**Consultation Response KC Landscape**

<b>Planning Number:</b>	2025/92683		
<b>Proposal:</b>	Discharge of details reserved by conditions 17 (landscaping), 18 (solar array) and 21 (tree T10/bats) on previous permission 2024/91760 for erection of 19 dwellinghouses with associated car parking, landscaping and boundary treatment and other associated works		
<b>Location:</b>	Land adj Healey Junior Infants and Nursery School, Healey Lane, Healey, Batley, WF17 8BN		
<b>DEVELOPER/APPLICANT/AGENT:</b>	GWP Architecture		
<b>Planning Officer:</b>	William Simcock		
<b>Date Responded:</b>	5 Jan 2026	<b>Responding Officer:</b>	Landscape
<b>Site Area (Hectares)</b>		<b>Responding Ref:</b>	PP72

**NOTES/COMMENTS: COND 17 – Landscaping**

**Proposed Block Paving For Shared Surfaces.**  
Laying In 90° herringbone with Buff Colour.

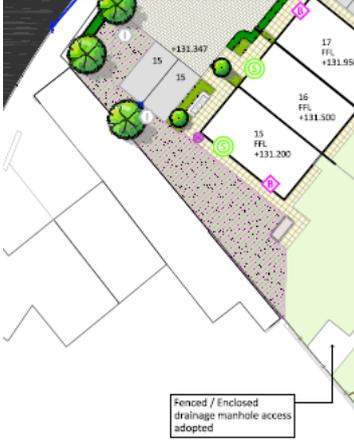
**17.e.:** We can't see the details for the hard surfacing – this needs to be provided to discharge this part e. We apologise if this has been submitted earlier as part of another submission, but please provide it to support this condition 17 landscape discharge information.
